# **ADDENDUM NO. 3**

## **OCTOBER 26, 2015**

PREPARED BY SCHMIDT ASSOCIATES FOR:  
**DEER CREEK SHOOTING RANGE**  
**INDIANA DEPARTMENT OF NATURAL RESOURCES**

“A3-1A-CU101.”

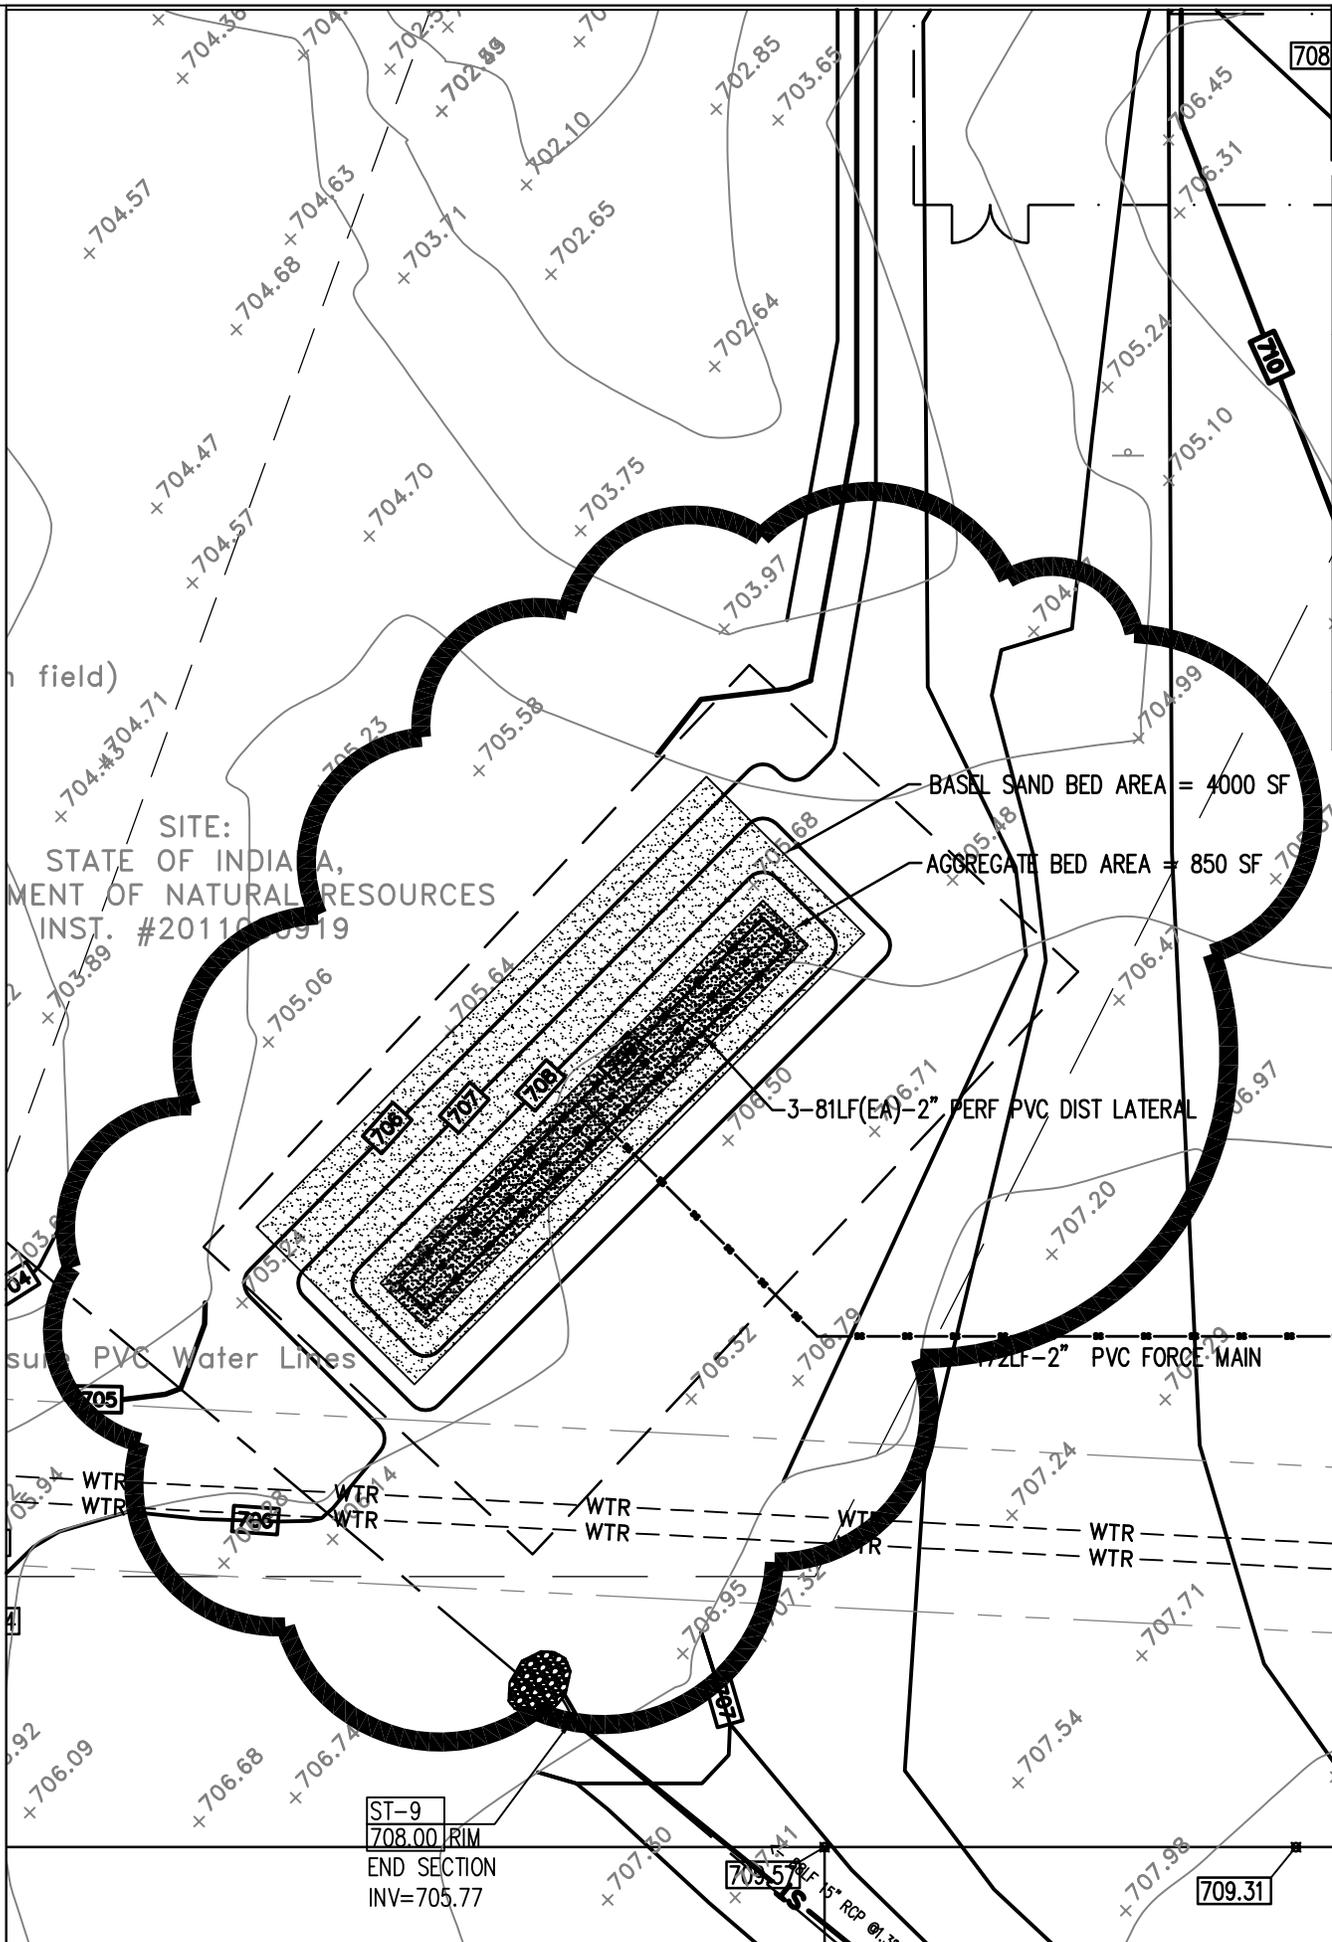
##### **A. Drawing Number CU101**

3. MODIFY Plan per attached:

**5C**

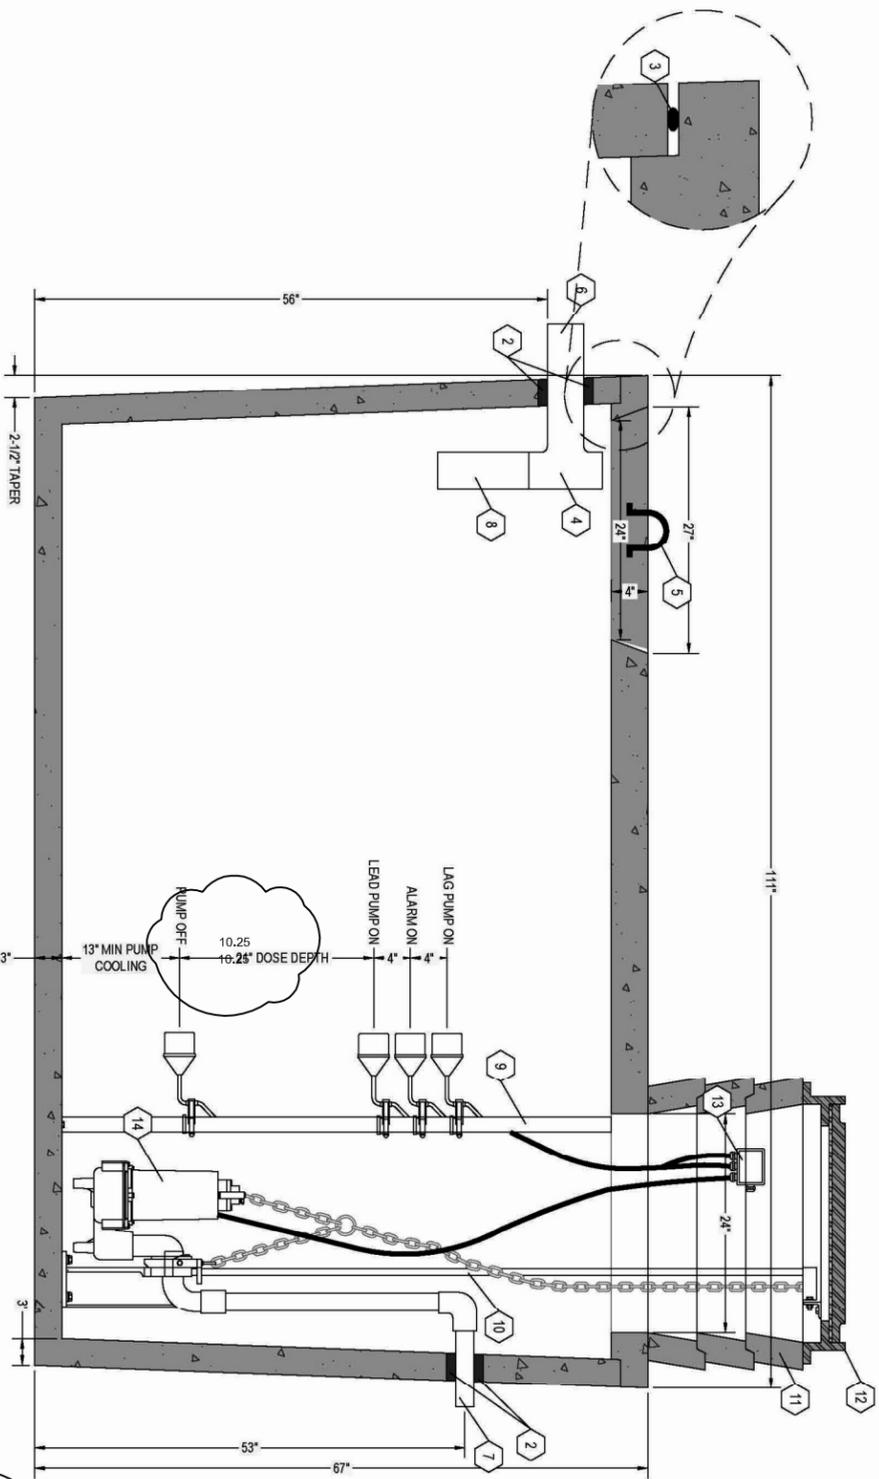
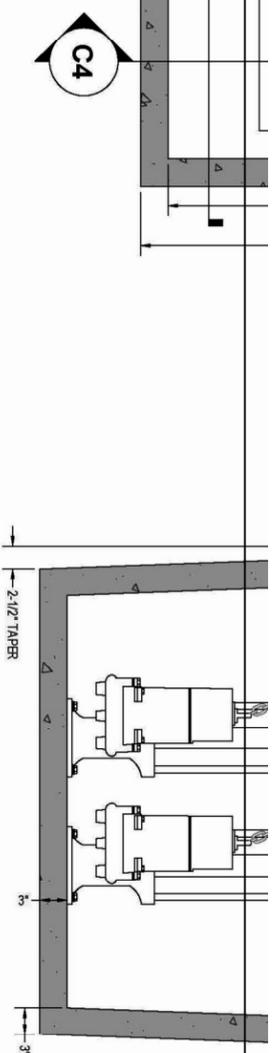
B. Drawing Number **CU401**

1. MODIFY Plan per attached:

“A3-5C-CU401.”

“Precast concrete dosing tank 1000 gal. See detail 5C/CU401.”
